August 4, 2023

To: City of Madison Landmarks Commission

Re: Old Spring Tavern property and proposed house at 3701 Council Crest
Legistar File ID No. 79099

Furlow Application Point 6.

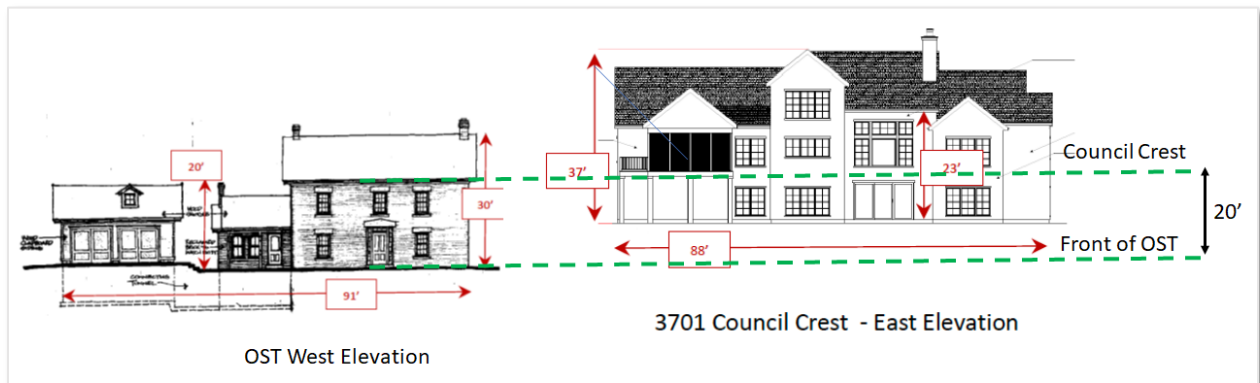
- The Furlows say the proposed house is consistent in scale with the Tavern and show side-by-side comparisons of the two-story front of the house with the two-story front of the Tavern, and the three-story back of the house with the three-story back of the Tavern.

- This is the wrong comparison. The appropriate comparison would show the three-story back of the house with the two-story front of the Tavern, because those are the two sides of the buildings that would face each other, only 26 yards apart. (The distance between the two buildings would be short; 26 yards is less than the distance between home plate and first base on a baseball diamond, for instance.)

- The front of the Tavern is 30 feet high and the back of the proposed house is 37 feet high, and the base of the three-story back of the house would be on higher ground (10 feet higher) than the two-story front of the Tavern, so the top of the proposed house would be 47 feet above the base of the Tavern while the top of the Tavern is 30 feet above its base, a significant and incompatible difference.

- All of this means that the proposed house would overshadow the Tavern and be incompatible with it because of its height, mass and close location.
- We have provided a drawing below to illustrate the relative height and mass differences between the sides of the two buildings that would face each other.
